# SERVICE BULLETIN

## CHECKING OR REPLACEMENT OF THE PROPELLER GEARBOX FOR ALL VERSIONS OF THE ROTAX<sup>®</sup> ENGINE TYPE 912 AND 914

**SB-912-027**

**SB-914-010**

Bild / fig. 1

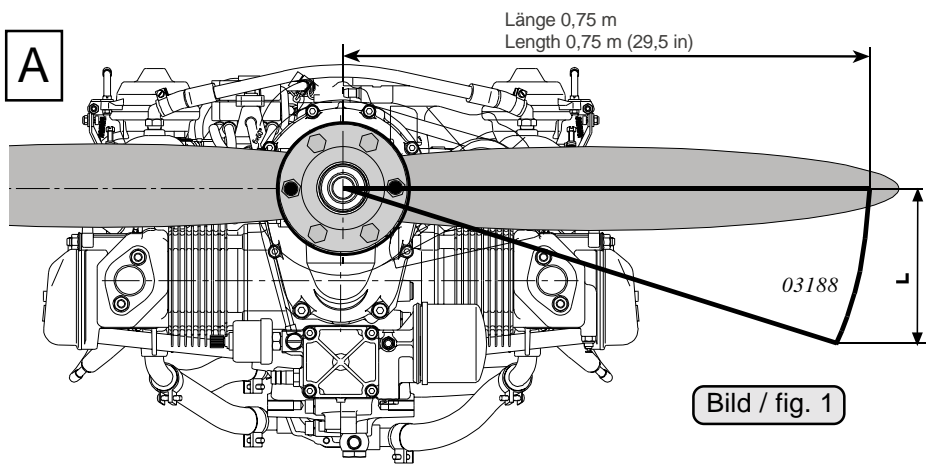
|| - The distance or angle of propeller blade moving along the complete backlash can be checked with a suitable device as follows:

Measured at a radius of 0,75 m (29,5 in) the backlash is on:

- doghub of **15° backlash: L less than 315 mm (12.4 in)**

- doghub of **30° backlash: L more than 315 mm (12,4 in)**

|| **ATTENTION:** The reason for a backlash of more than 315 mm (12,4 in) could be an unsuitable combination of doghub and doggear. Replace the gearbox according to instructions.

|| If the measured backlash is less than 315 mm, the gearbox is unaffected and no further measures are necessary.

Bild / fig. 2 00620

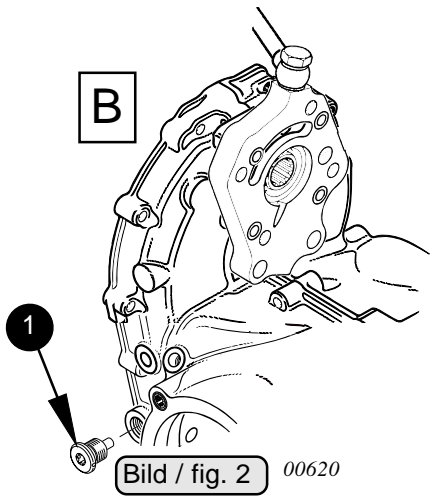
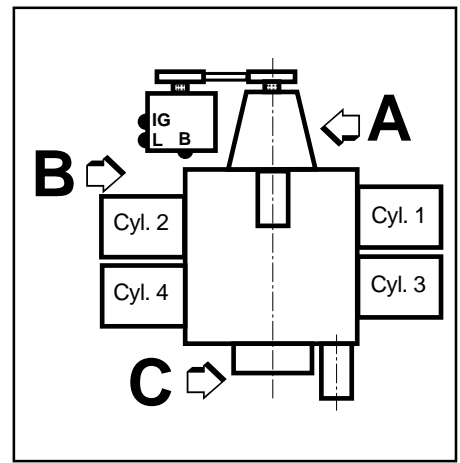
- Remove the magnetic drain plug (1) located in front left side of the crankcase and inspect plug for chips. Clean the magnetic plug and refit. Tightening torque 25 Nm (220 in.lb).

Bild / fig. 3

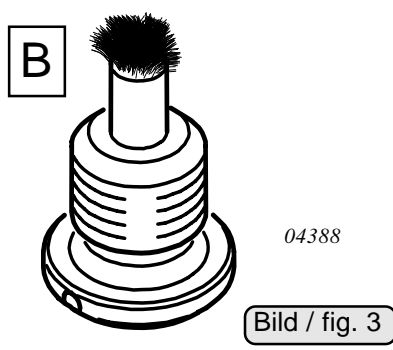
- **ATTENTION:** Steel chips in low numbers as depicted in fig. 3 can be tolerated if the size is below 3 mm (1/8").  
Also sliver-like chips can be tolerated as long as length does not exceed 10 mm (3/8") and the dia. is not above 0,05 mm (0,002").

Bild / fig. 4 00375  
00376

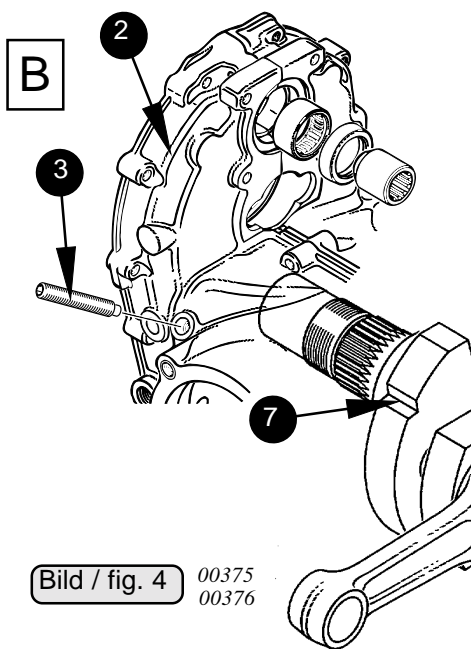
- To lock the crankshaft remove the plug screw M8x20 and sealing ring from the crankcase half cyl. 2/4 (2). Turn crankshaft until the pistons of cyl. no 1 and no. 2 are in T.D.C. and lock crankshaft in this position with the crankshaft locking screw (3) (part no. 240.880).

- ◆ **NOTE:** The crankshaft locking screw is part of the standard tool kit supplied with each engine.
- For easy location of the correct crankshaft position, turn crankshaft so that the impressed 4-digit number (4) on the flywheel hub(5) aligns with the edge (6) of the ignition housing.  
For this verification, the ignition cover has to be removed as follows (if fitted):

Bild / fig. 10

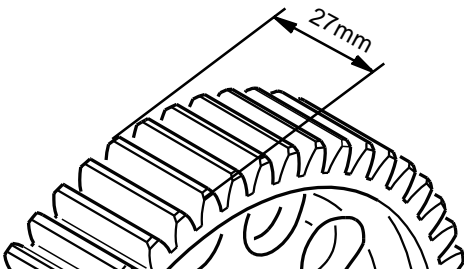
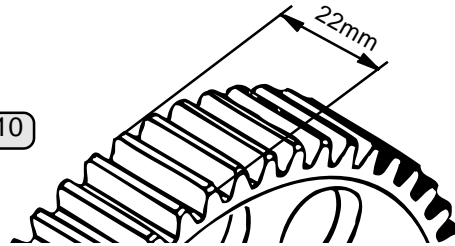
■ ATTENTION: dog hub with 7° tapered surface (use only for gear set with dog gear of 27 mm width)

■ ATTENTION: dog hub rectangular surface (use only for gear set with dog gear of 22 mm width)

◆ NOTE: The repaired or replaced gearbox is also with a backlash of 30°, but is equipped with a dog hub of rectangular surface (see fig.11).

Slide drive gear (19) onto crankshaft (20). Fit hex. nut (21) M30x1,5 secured with LOCTITE 221 and friction washer (22) VS 30 on crankshaft. Torque to 200 Nm (1770 in).

■ ATTENTION: Dog gear and drive gear are paired and are marked with a consecutive serial number (23). Use only parts of the same serial number!

Bild / fig. 11 04111

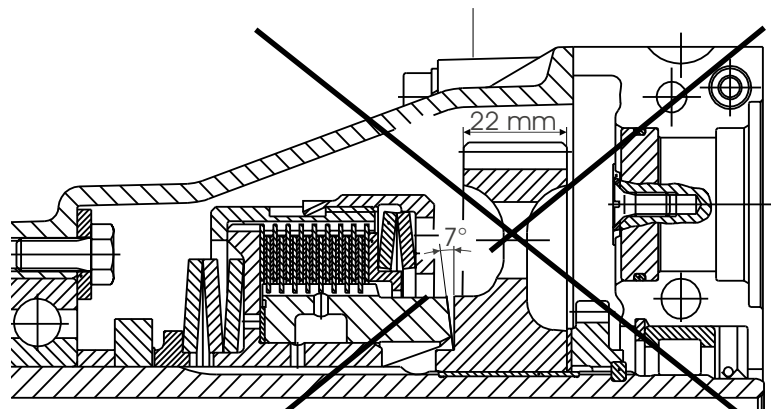
|| An unsuitable combination of a 7° tapered doghub and a 30° backlash doggear may have been installed in the gearbox of the engines affected.

FALSCH KOMBINATION /  
WRONG COMBINATION
